**PETITION FOR CHANGE OF THE PROJECT DESCRIPTION IN THE FINAL
DECISION TO EXPAND AN EXISTING SWITCH GEAR ENCLOSURE AT
PALOMAR ENERGY CENTER
(01-AFC-24C)**

**SAN DIEGO GAS & ELECTRIC COMPANY
SAN DIEGO, CALIFORNIA**

CALIFORNIA ENERGY COMMISSION

AUGUST 3, 2011

FLOOR PLAN

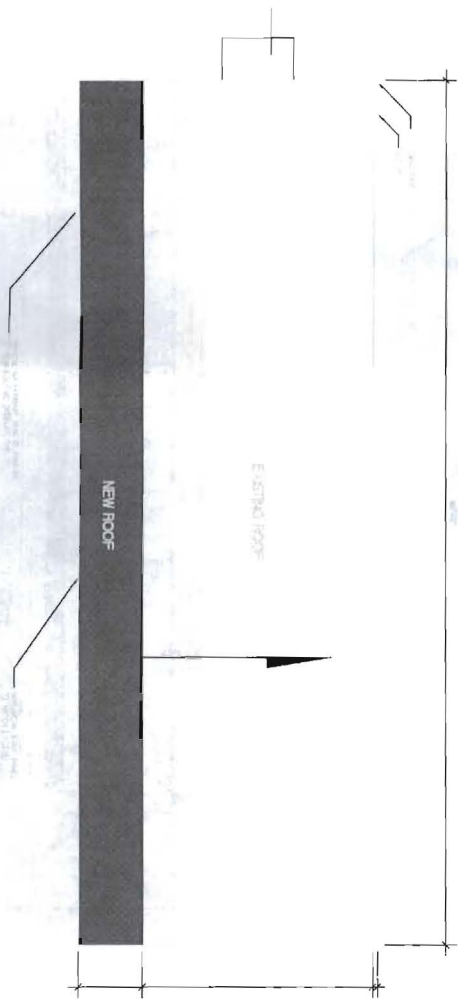
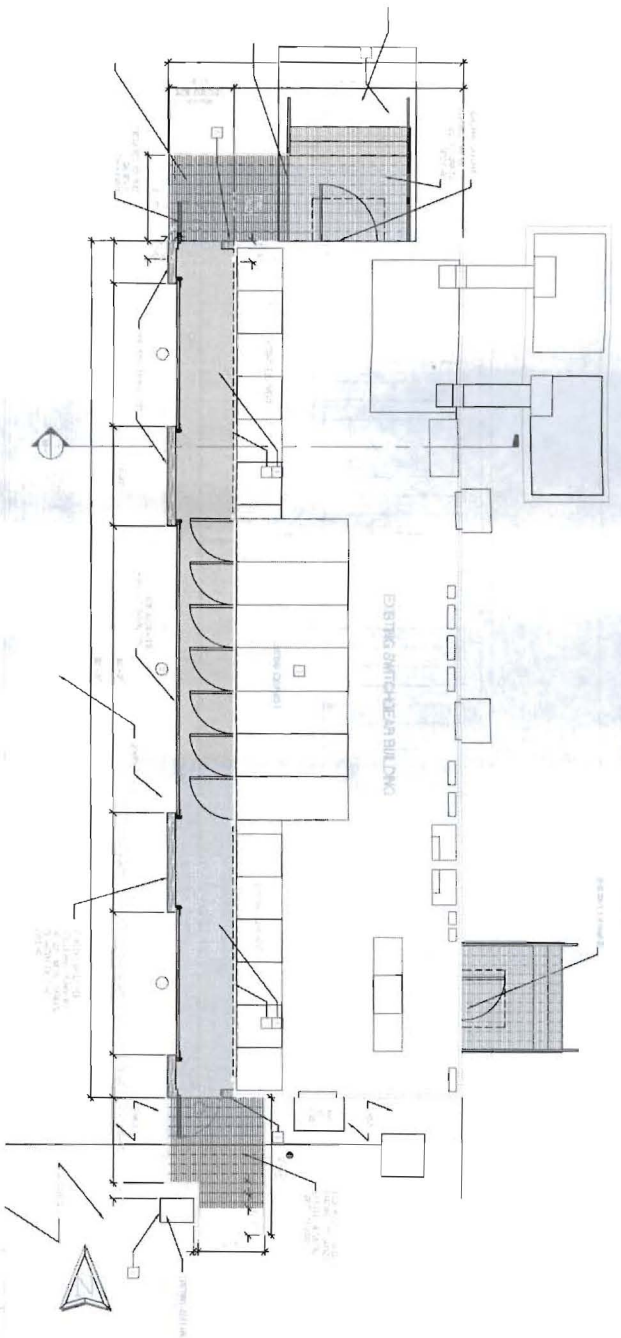
EC Switch Gear Structure Improvement. SDG&E is proposing to add a 270 square foot expansion to the existing 960 square foot switch gear enclosure. The expansion will improve lighting, improve access and location of electrical outlets, and improve access to equipment housed in the enclosure. The expansion will also be fitted with three roll-up doors and two doors for easy access to maintain and repair equipment in the enclosure. The addition of the 60'X4.5' of usable work space will ensure a safe working environment when performing maintenance, repairs, and/or inspections of the equipment. The outer surfaces of the building will be painted the plant color (SW 1022 Cubist grey). Plot plans showing the location of the building and visual simulations are attached in Appendix 1.
